MEMORANDUM

TO: ARCHITECTURAL REVIEW BOARD
FROM: Kate Schwartz, Historic Resources Planner
DATE: April 11, 2016
SUBJECT: Certificate of Appropriateness for exterior alteration at 1109 Caroline Street

Pamela McLeod Giegerich requests a Certificate of Appropriateness to construct a five feet six inch tall brick and block wall along the south side of the rear yard.

Plat provided by the applicant.
Proposed wall will be constructed in the same location as the previous "Block Wall."

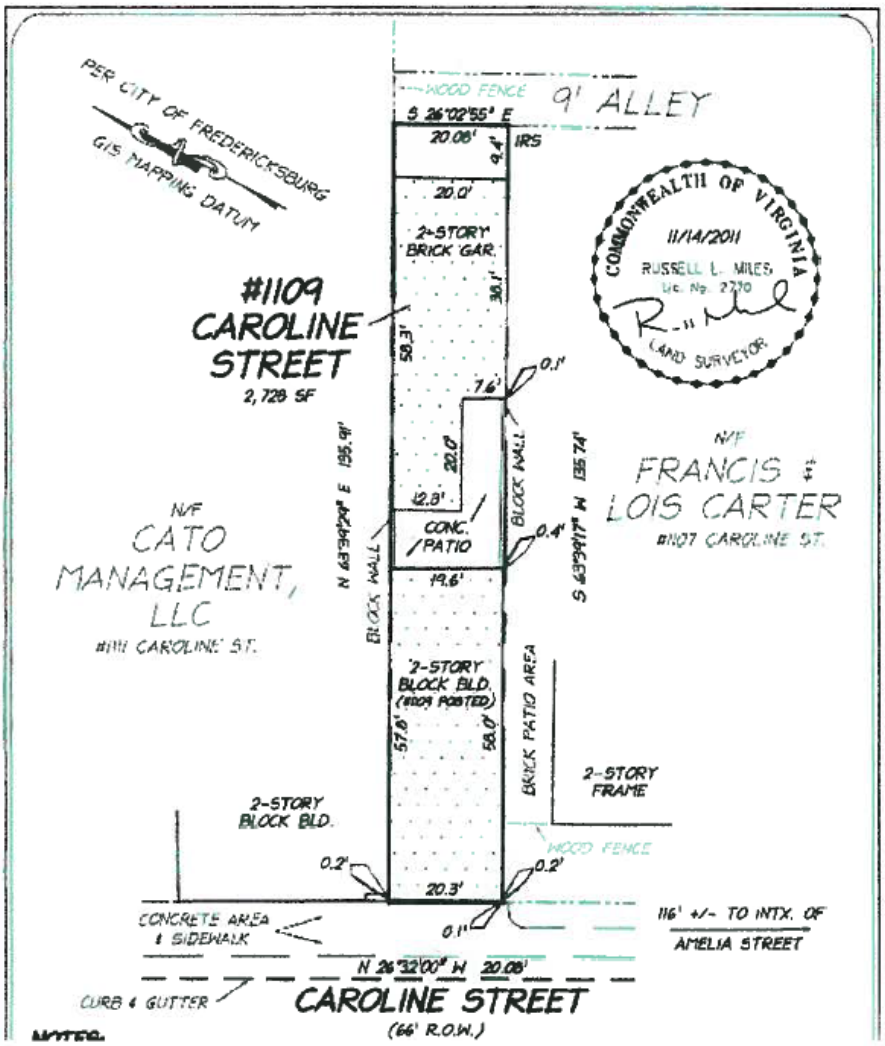
The neighboring property owners at 1107 Caroline Street erected a chain-link fence along this property line without approval. The applicant and City staff are working with the neighbors to remove the chain-link fence in coordination with installation of the proposed wall. The new wall will be minimally visible from both Caroline Street and from Amelia Street. The wall will begin at the southeast corner of the primary structure and extend for 25 feet along the south property line. The design consists of three (3)

Approval of the Certificate of Appropriateness for installation of a concrete-block wall faced with either brick or a stone composite material on condition that: the existing unapproved chain-link fence be removed from the site.

Sketch of Wall - Sideview

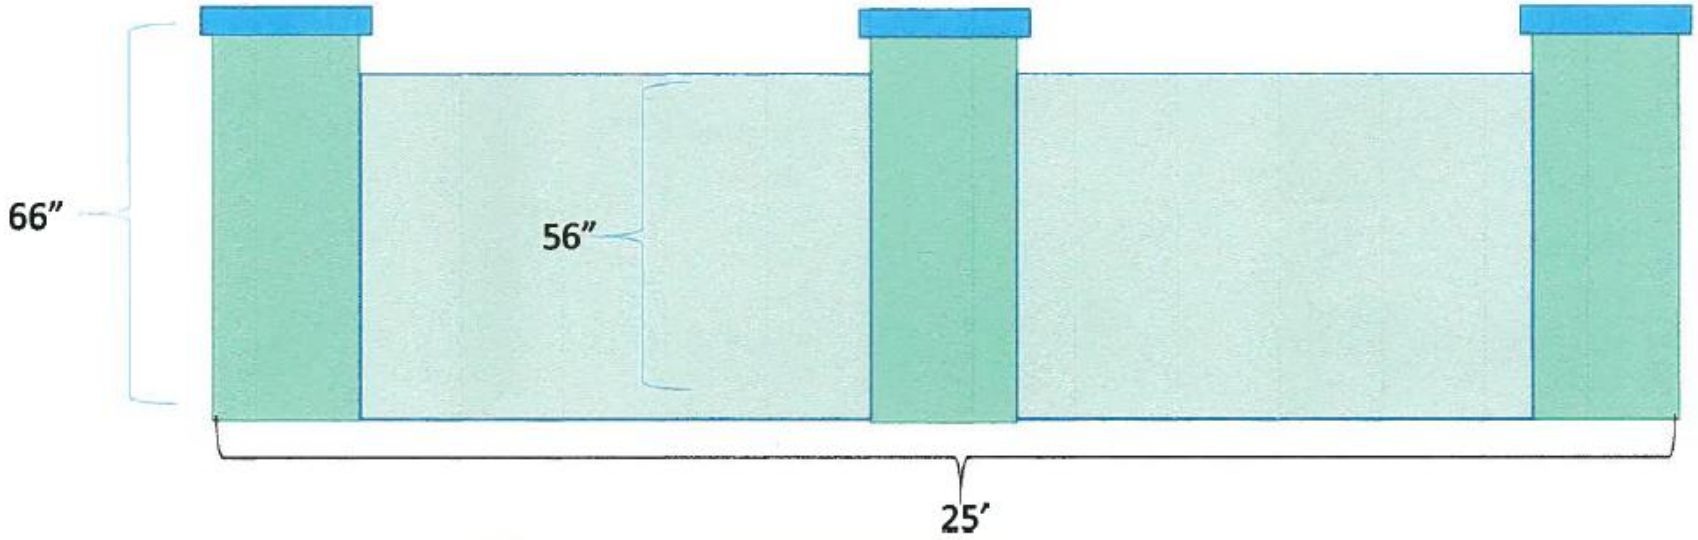
piers, 5 feet 6 inches in height, with 4 feet 8 inch tall sections of wall running between the piers. The wall will be constructed of concrete block and faced with either brick or a stone composite depending on material availability. Both facing materials are compatible with the character of the historic district and would not adversely affect the historic character of the property or the district. Staff finds that the proposed wall meets the standards and guidelines for the historic district.
